## **ADDENDUM NO. 1**

Friendship Park  
Infield Turf @ Fields 1, 2, 3, & 4 And  
Infield Turf & Outfield Grading @ Fields 6 & 7  
City of Picayune, Mississippi  
Pearl River County, MS

Dungan Engineering, P.A.  
925 Goodyear Boulevard  
Picayune, Mississippi 39466

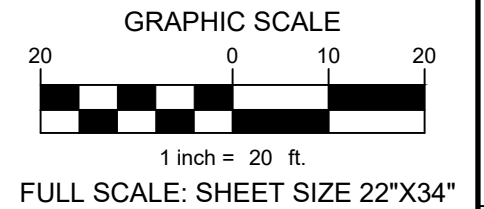
- Add Sheet 3.02A to the construction drawings. The purpose of sheet 3.02A is to provide a drainage and grading plan to scale for Field 6 for determining takeoff dimensions and quantities.
